City of
Melville

MINUTES
DEVELOPMENT ADVISORY UNIT MEETING

Matters for consideration	Notes from meeting
UP25/82	Two Grouped Dwellings at Lot 30 (No.50) Blackwall Reach Parade, Bicton

UP25/82 Two Grouped Dwellings at Lot 30 (No. 50) Blackwall Reach Parade, Bicton

Figure 3. Unit 2 Northern Elevation with Blue Area Showing Bed 1 Roof Over 9m.

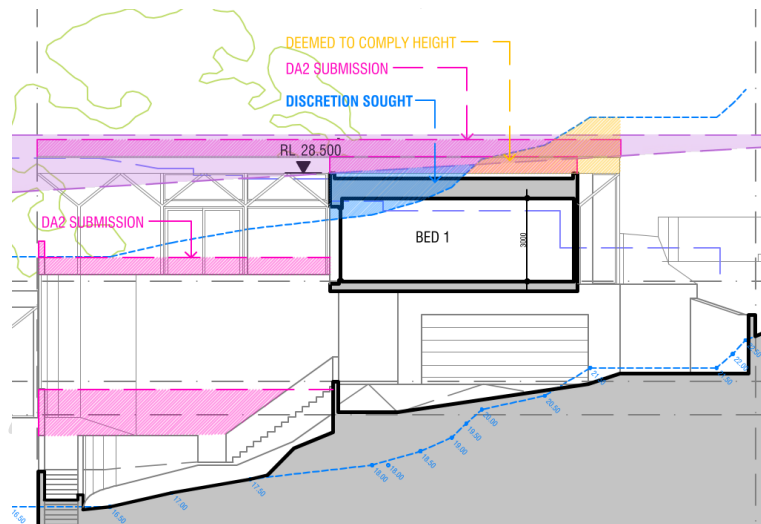
Concerns were raised by the submitters in relation to the building height of proposed Unit 2. As noted above, the proposed development does not meet the deemed to comply provisions within LPP1.9 in and requires a R-Codes design principles assessment. The proposed development is considered to meet the relevant design principles as discussed below:

Design Principles	Assessment:
<p><i>P6: Building height that creates no adverse impact on the amenity of adjoining properties or the streetscape, including road reserves and public open space reserves; and where appropriate maintains:</i></p> <ul style="list-style-type: none"> • <i>adequate access to sunlight into buildings and appurtenant open spaces;</i> • <i>adequate daylight to major openings into habitable rooms; and</i> • <i>access to views of significance.</i> 	<p>P6:</p> <ul style="list-style-type: none"> • Overall, the subject site has a fall of approximately 11m from both east to west and north to south which creates a significant design challenge for the proposed development especially regarding building height. While the entirety of Unit 1 and the majority of Unit 2 meet the deemed-to-comply height criteria, a steep drop in ground level of approximately 6.5m below proposed Unit 2’s bed 1 (figure 2) results in the roof exceeding 9m in height above NGL in this location. The applicant has provided figures 3 and 4 below which show the portion of the Unit 2 bed 1 that exceeds 9m in height in blue. • The proposal complies with Clause 5.4.2 ‘Solar access to adjoining sites’ which ensures there will be adequate sunlight available for adjoining properties despite the height of proposed Unit 2. • When considering the subject sites topography, it is considered the impact on No.4 Lindsay Place’s views of significance will be minimal for the following reasons: <ul style="list-style-type: none"> ○ Figure 3 below shows in yellow the rear portion of Unit 2 could be constructed higher as of right while still meeting the 9m maximum deemed-to-comply height criteria. This portion shown in yellow would cause more disruption to the views of No.4 Lindsay Place than the portion of the Unit 2 bed 1 roof for which discretion is sought. ○ Views from No.4 Lindsay Places first floor are depicted in figures 5 and 6 below where impacts on views of significance will be minimal. Specifically, there is only one bedroom on the first floor of No.4 Lindsay Place directly facing the portion of the proposed dwelling over 9m in height. In addition, the proposed bed 1 roof (reduced level (RL) 28.50m) will be approximately 0.8m higher than the finished floor level (FFL) of No.4 Lindsay Places first floor (RL 27.70m) which will still allow for views of the river from No.4 Lindsay Places first floor. ○ The second floor of No.4 Lindsay Place has an FFL above the roof level of the proposed dwelling and therefore will be unaffected as depicted in figures 7 and 8 below. • No other surrounding properties will have a loss of significant views because of proposed Unit 2’s bed 1 roof height.

Figure 9. Unit 1 Western Bed 1 to Bed 2 Wall Setback from No.50A Blackwall Reach Parade Boundary Marked in Yellow.

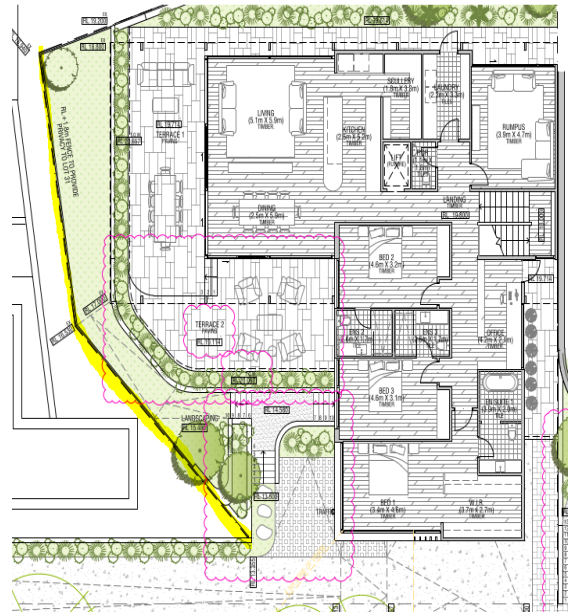
Design Principles	Assessment:
<p>P3.1: Buildings set back from lot boundaries or adjacent buildings on the same lot so as to:</p> <ul style="list-style-type: none"> • reduce impacts of building bulk on adjoining properties; • provide adequate sunlight and ventilation to the building and open spaces on the site and adjoining properties; and • minimise the extent of overlooking and resultant loss of privacy on adjoining properties. 	<p>P3.1:</p> <ul style="list-style-type: none"> • When considering the lot boundary setbacks, it is important to note that the subject site has a steep topography which creates a significant challenge for the proposed dwellings design. • When considering the sites topography, it is considered the bulk impacts of the proposed lot boundary setbacks will be minimal on adjoining properties for the following reasons: <p><u>No.50A Blackwall Reach Parade</u></p> <ul style="list-style-type: none"> ○ As per figure 9, a section of approximately 2.3m in length and 2.6m² in area of the Unit 1 bed 1 to bed 2 wall will be within 4.1m-6.3m of the lot boundary. This portion of wall is not considered to be excessive in size therefore minimising bulk impacts. ○ The Unit 1 bed 1 to bed 2 wall will be setback approximately 9.3m from No. 50A Blackwall Reach Parade’s master bedroom courtyard. As such, this

wall, is sufficiently setback from the dwelling at No. 50A Blackwall Reach Parade to avoid unacceptable bulk impacts.

Figure 10. Unit 1 Western Terrace Setback from No.50A Blackwall Reach Parade.

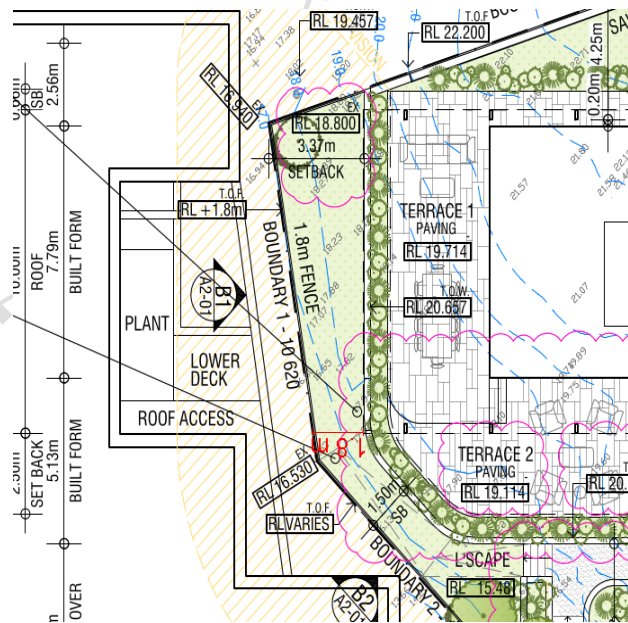
- Proposed Unit 1's terrace is an open structure.
- There are no habitable rooms with major openings at No. 50A Blackwall Reach Parade facing the subject site. The proposed Unit 1 terrace roof will be adjacent to a drying court, lightwell and mechanical plant at No. 50A Blackwall Reach Parade. Given there are no habitable rooms at 50A Blackwall Reach Parade with major openings facing the proposed terrace and the terrace will not directly abut any sensitive spaces, the bulk impacts are deemed acceptable.

Figure 12. Unit 2 Eastern Rumpus to Stairs Setback from No.4 Lindsay Place Marked in Yellow.

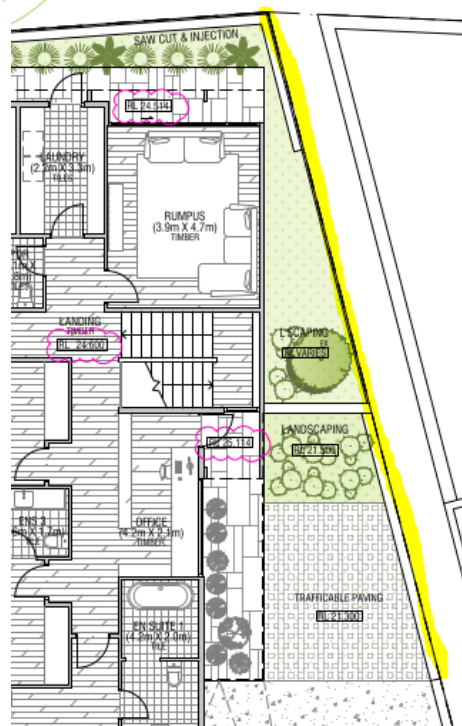
- A section of approximately 2.5m in length and 0.9m² in area of the Unit 2 rumpus to stairs wall will be within 1.5m of the lot boundary with No.4 Lindsay Place as per figure 12. The height of this portion of the wall is between 3.7m to 4.5m above NGL at the boundary noting that this portion of the building complies with LPP 1.9 'Height of Buildings'. This portion of the wall is not considered to be excessive in size therefore minimising bulk impacts.
- The majority of No.4 Lindsay Place's outdoor living area will be unaffected by the proposed Unit 2 rumpus to stairs. No.4 Lindsay Place's ground floor family room is adjacent to this portion of wall and is setback approximately 5.9m which is considered sufficient to ensure minimal bulk impacts. The first floor of No.4 Lindsay Place has an FFL higher than the roof level of proposed Unit 2 and will not be impacted.

Figure 15. Western Boundary Retaining Walls Marked in Brown and Blue.

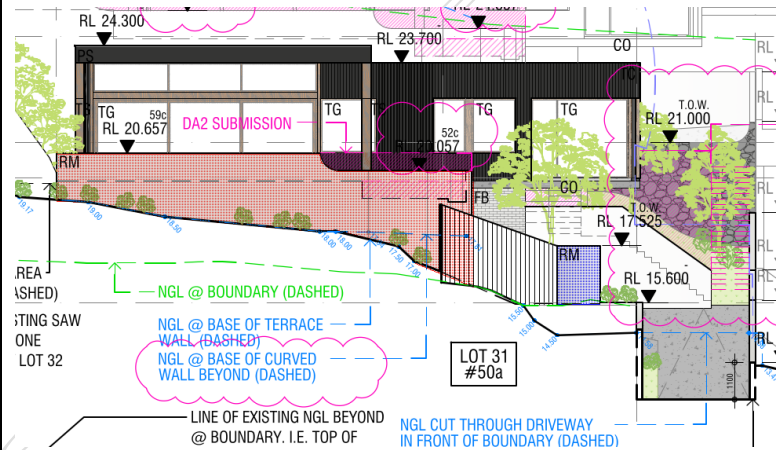
Design Principles	Assessment:
<p>P7.1: Development that considers and responds to the natural features of the site and requires minimal excavation/fill.</p> <p>P7.2: Where excavation/fill is necessary, all finished levels respecting the natural ground level at the lot boundary of the site and as viewed from the street.</p> <p>P7.3: Retaining walls that result in land which can be effectively used for the benefit of residents and do not detrimentally affect adjoining properties and are designed, engineered and landscaped having due regard to clause 5.4.1.</p>	<p>P7.1:</p> <ul style="list-style-type: none"> The site has a challenging topography with a fall of approximately 11m from both east to west and north to south. The design of the dwellings and the proposed retaining walls are considered to appropriately respond to the site’s natural topography. <p>P7.2:</p> <ul style="list-style-type: none"> Due to the majority of the siteworks along the driveway being cut, the impacts on the streetscape will be minimal. <p>P7.3:</p> <ul style="list-style-type: none"> The proposed retaining walls will result in land which can be effectively used for the benefit of residents and will not detrimentally affect adjoining properties for the following reasons: <p><u>Western Boundary:</u></p> <ul style="list-style-type: none"> Figure 15 below shows the two separate retaining walls along the western boundary in red and blue that do not meet the deemed-to-comply site work criteria. The red terrace retaining wall ranges in height from 3.7m to 4.4m as per figures 16 and 17 and is within 3m of the boundary with No. 50A Blackwall Reach Parade as per figure 18. The blue retaining wall is 2m high and is located on the boundary as per figures 16-18.

- Regarding the spaces at No.50A Blackwall Reach Parade that the proposed retaining walls will be adjacent to, figure 18 shows these include a drying court, lightwell, mechanical plant and the master suite courtyard. No habitable rooms with major openings at 50A Blackwall Reach Parade face the proposed retaining walls. In addition, No.50A Blackwall Reach Parade’s primary living space and outdoor living area are located on the western and north-western portions of their dwelling away from the proposed retaining walls. As such, it is considered the proposed retaining walls will not detrimentally affect No.50A Blackwall Reach Parade as they will not directly abut any sensitive spaces.

Figure 19. Height of Southern Boundary Retaining Wall with Wall in Pink Being Originally Proposed and Wall in Yellow Being Currently Proposed.

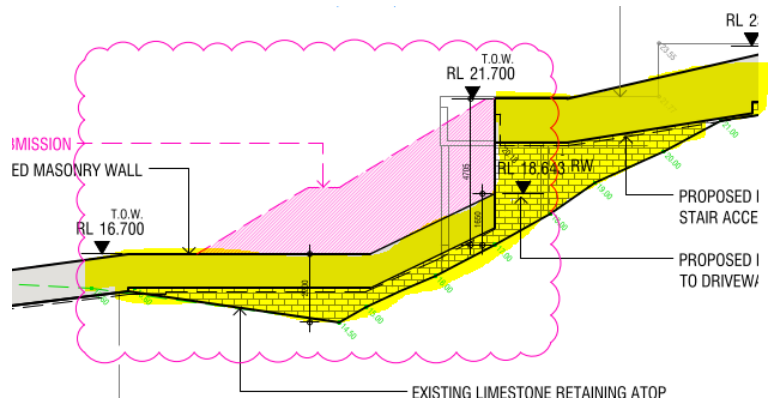
- The 4.7m high combined retaining and masonry wall along the southern boundary shown in figure 19 below is necessary to provide both vehicular and pedestrian access. The proposal involves mostly cut along the western portion of the access which is then balanced with retaining above NGL further up the site. A small portion of the masonry wall exceeds 0.5m in height where it abuts No.52 Blackwall Reach Parade with the majority of the combined retaining and masonry wall abutting 11 Barker Pl. The small portion of the masonry wall over 0.5m above NGL abutting No.52 Blackwall Reach Parade will have minimal impacts as it does not directly abut any sensitive spaces. Figure 20 below shows the highest portion of the southern retaining and masonry wall in relation to 11 Barker Place where it can be seen that the FFL of their dwelling is a similar height to the top of the retaining wall. Figure 21 also shows No.11 Barker Place only contains one window facing the subject site. It is therefore considered the

impacts on No.52 Blackwall Reach Pde and No.11 Barker Place from the proposed site works are acceptable.

Figure 23. Unit 1 Bed 1 overlooking into Nos. 50A and 52 Blackwall Reach Parade to the west and south.

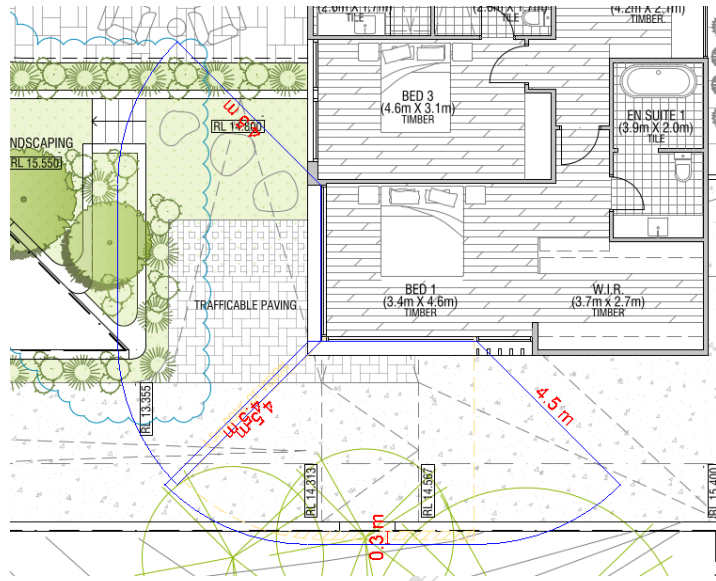
Design Principles	Assessment:
<p>P1.1: Minimal direct overlooking of active habitable spaces and outdoor living areas of adjacent dwellings achieved through:</p> <ul style="list-style-type: none"> • building layout and location; • design of major openings; • landscape screening of outdoor active habitable spaces; and/or • location of screening devices. <p>P1.2: Maximum visual privacy to side and rear boundaries through measures such as:</p> <ul style="list-style-type: none"> • offsetting the location of ground and first floor windows so that viewing is oblique rather than direct; • building to the boundary where appropriate; • setting back the first floor from the side boundary; • providing higher or opaque and fixed windows; and/or 	<p>P1.1 and P1.2:</p> <ul style="list-style-type: none"> • Figure 23 below shows the overlooking from Unit 1 Bed 1’s major opening of Nos. 50A and 52 Blackwall Reach Parade will be minimal. Specifically, the cone of vision overlooking of No.52 Blackwall Reach Parade will extend approximately 0.3m over the boundary and not impact any active habitable spaces. Therefore, the Unit 1 bed 1 overlooking is considered to have minimal privacy impacts. • Figure 24 shows the cone of vision overlooking from the Unit 1 Terrace towards No.50A Blackwall Reach Parade. This overlooking does not capture any major openings at No.50A Blackwall Reach Parade and the outdoor areas it captures include a drying court, lightwell, mechanical plant and master courtyard with a louvered roof. The overlooking therefore will not have any privacy effects on No. 50A Blackwall Reach Parade’s primary living space or primary outdoor living area. Figures 24 and 25 below highlight the sites steep topography with the primary outlook towards the river over top of No.50A Blackwall Reach Parade. A 1.8m fence is also proposed along this boundary which as can be seen in figure 26 below which will prevent a direct line of sight down towards No.50A Blackwall Reach Parade from a person standing on the terrace.
